CMW Addendum Number One (1)

Elizabethtown Freeman Lake Park Bandstand
Freeman Lake Park
Elizabethtown, Kentucky

25 June 2021

1 ELECTRIC LIGHTING SITE PLAN
 1" = 10'-0"

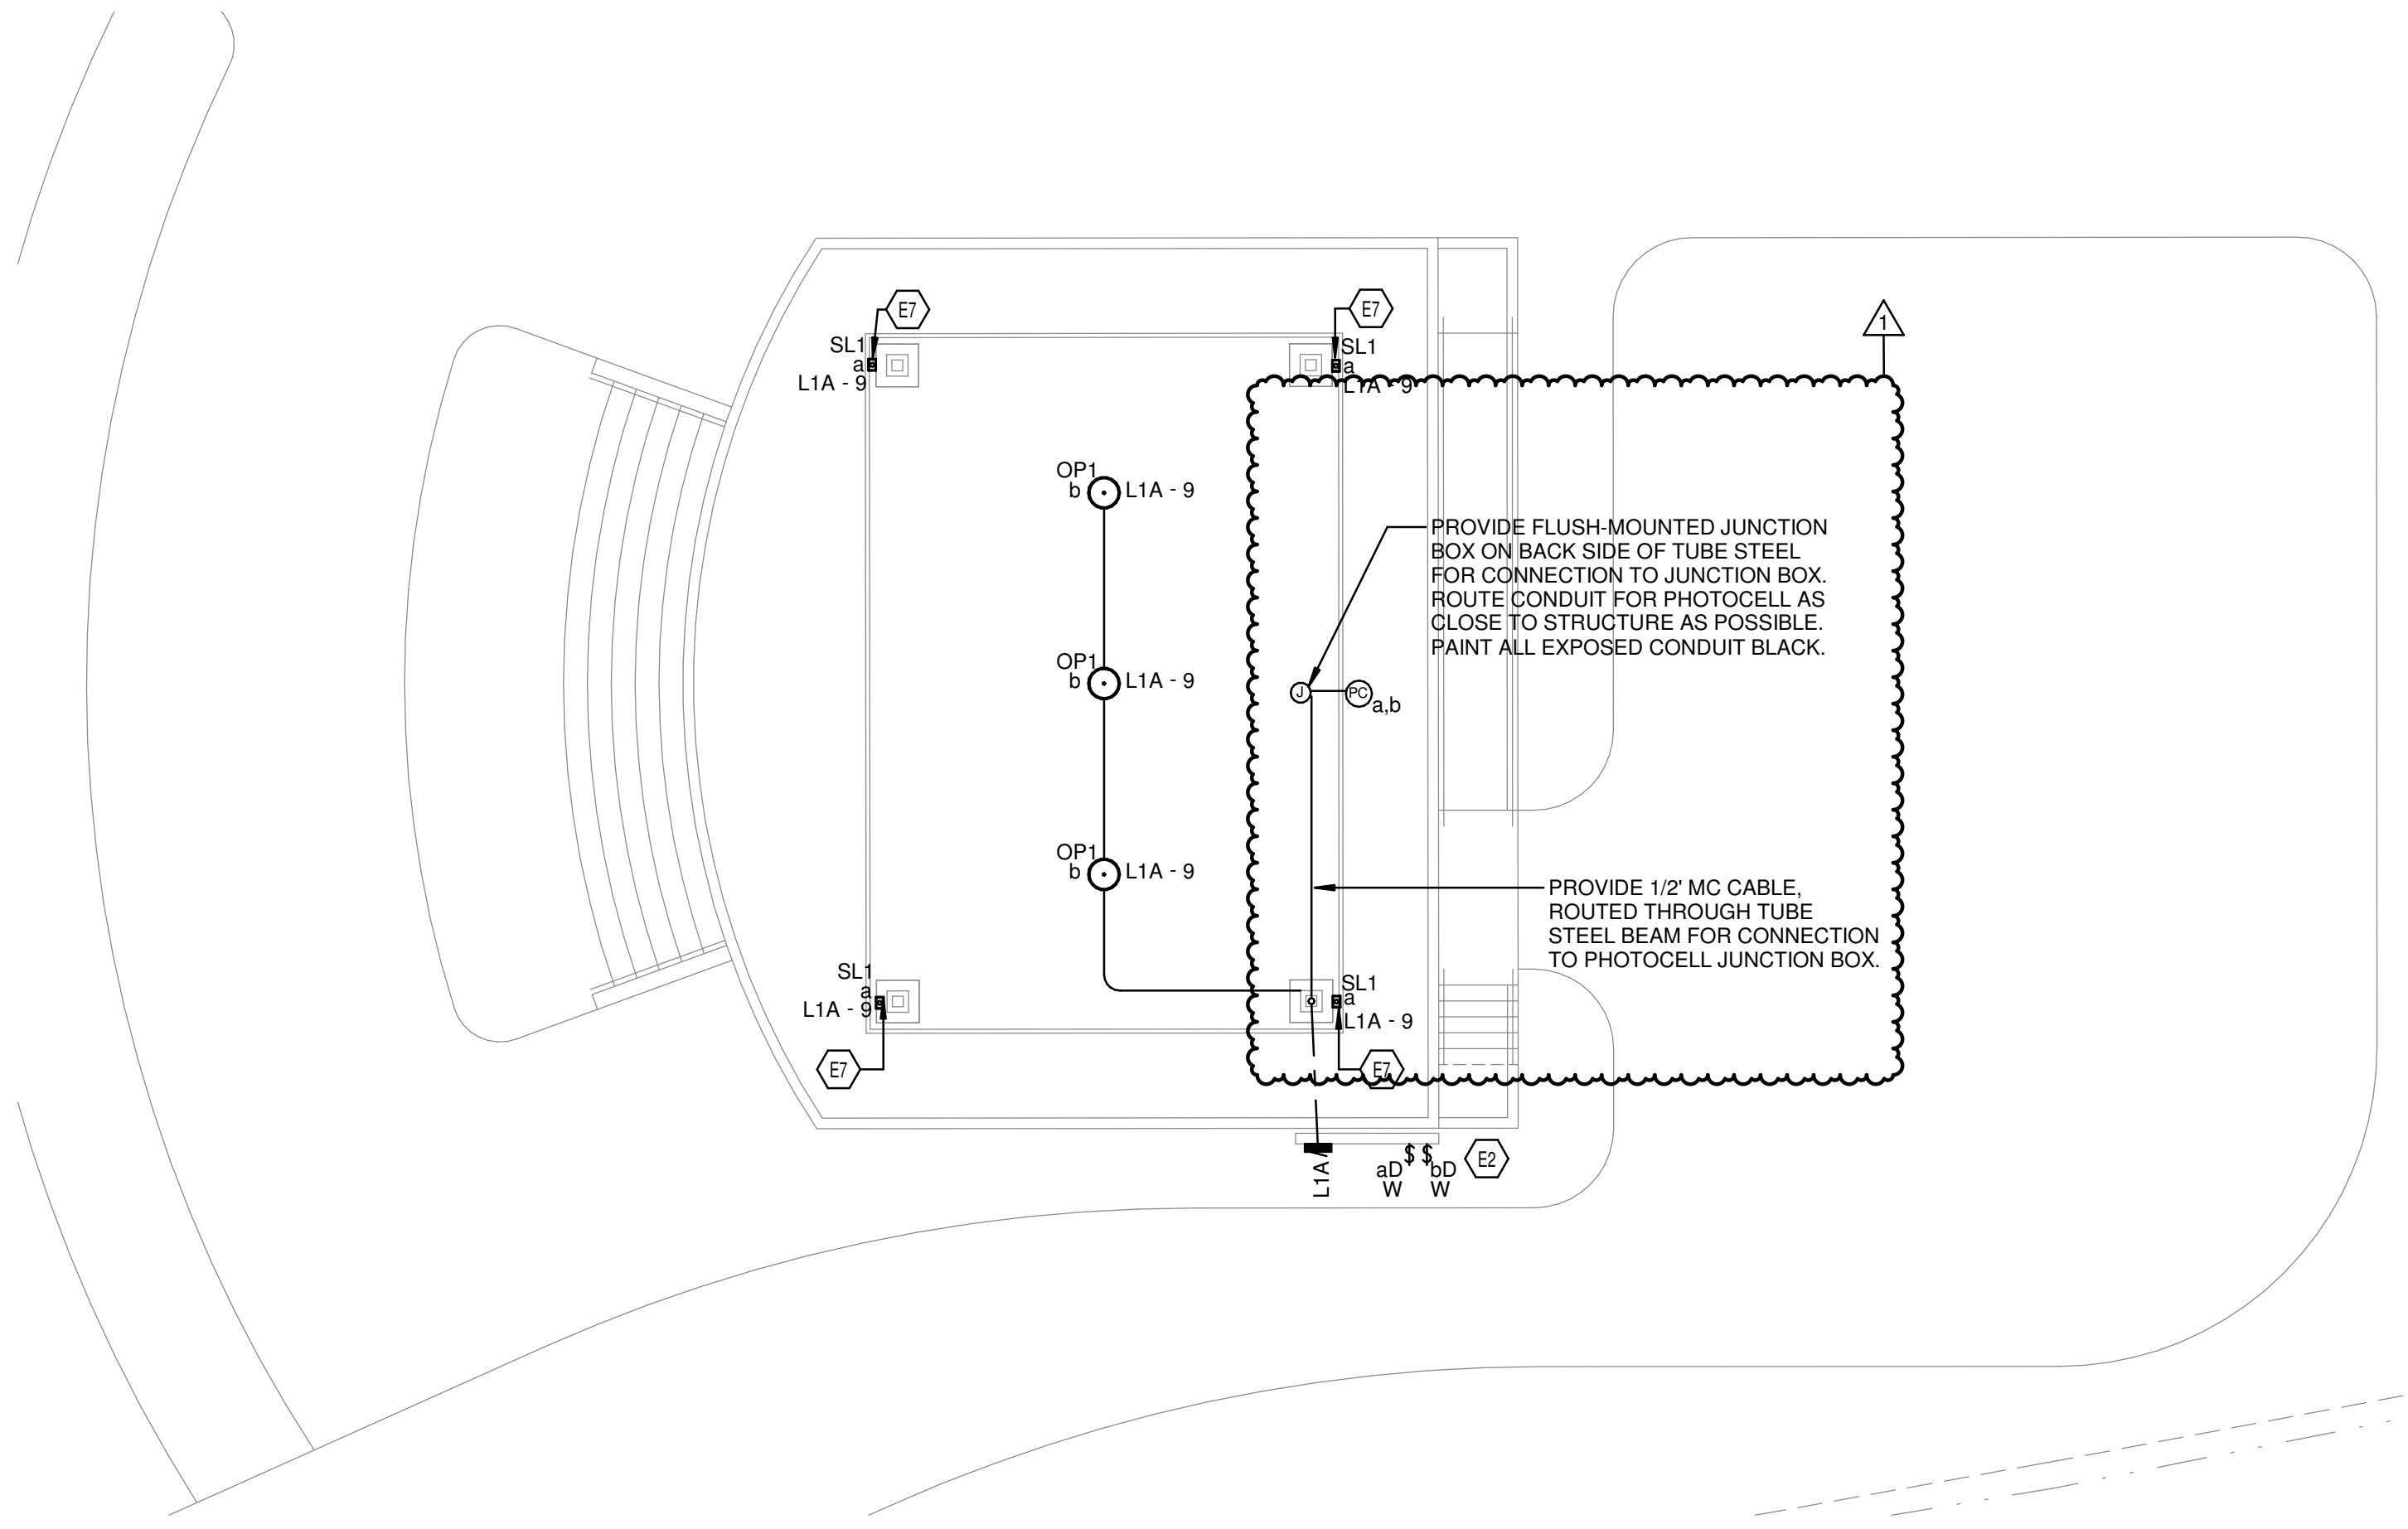
1. Refer to attached Drawing E1.1 (revision 1) for added requirements for photocell installation.

- E2 PROVIDE MANUAL ON AND OFF CONTROL OF LIGHTING WITH AUTOMATIC-OFF OVERRIDE VIA PHOTOCELL.
- E7 COORDINATE HEIGHT OF STEP LIGHT WITH ARCHITECTURAL ELEVATIONS AND DETAILS.

**SINGLE PHASE PRIMARY
TRANSFORMER
INSTALLATION**

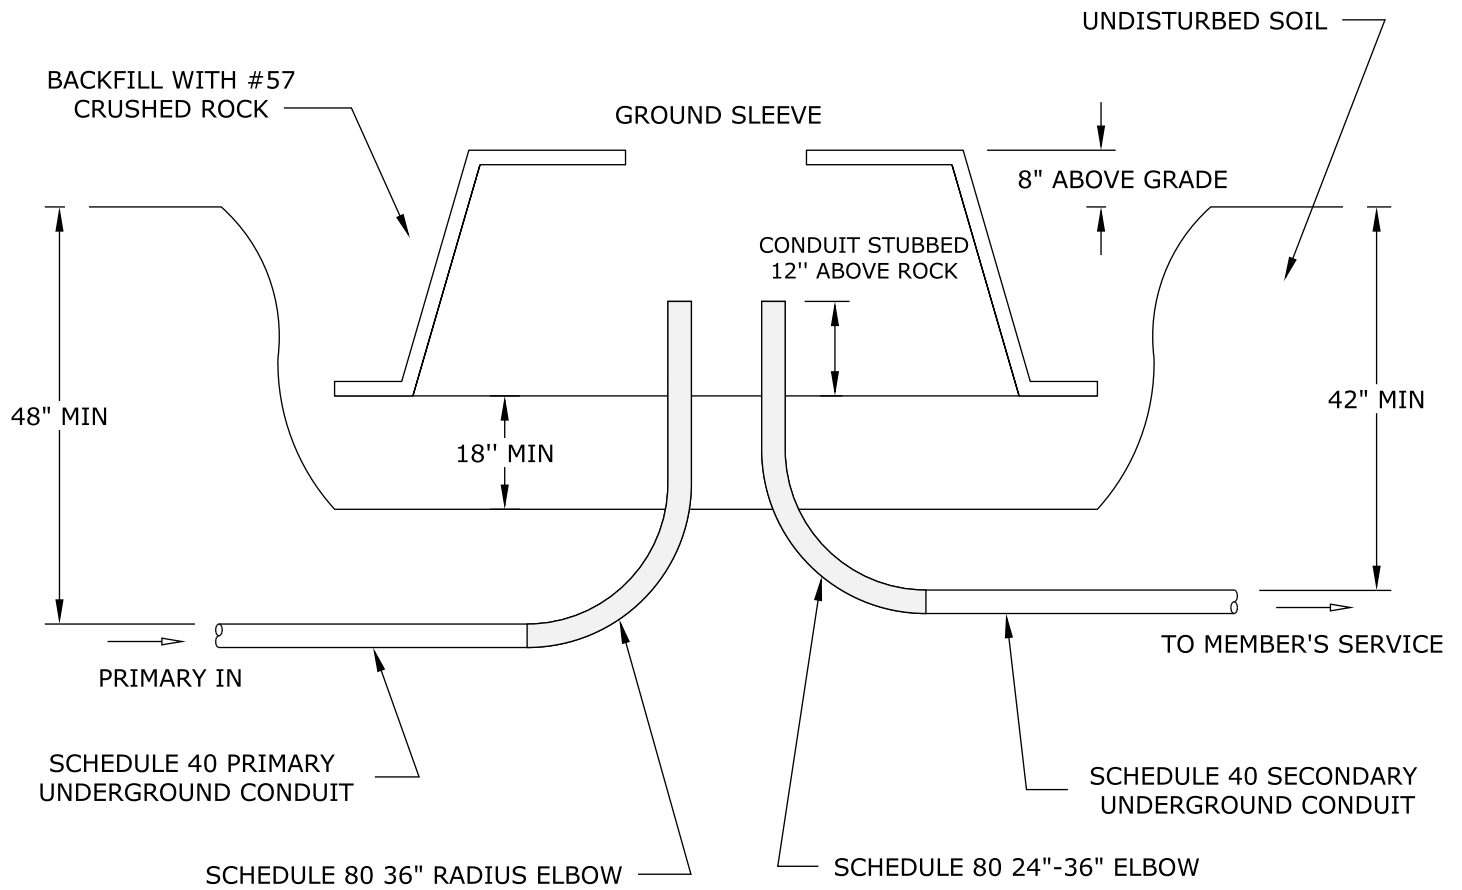
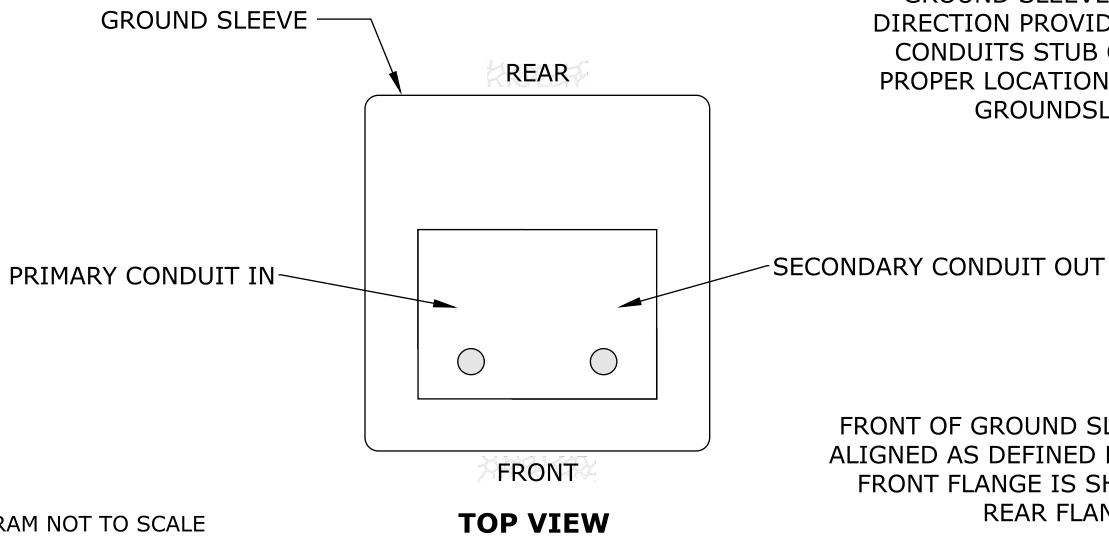
1. At the existing transformer pole (reference Keyed Note E1), NOLIN RECC has advised that a ground mounted transformer MAY be required to provide the electrical service to the Project in lieu of the existing pole mounted transformer. Refer to attached drawing "NOLIN RECC Single Phase Transformer Installation" (3 pages) for the ground mounted transformer. Bidders to provide Unit Prices to account for potential change from existing pole mount transformer to new fiberglass pad mount transformer.
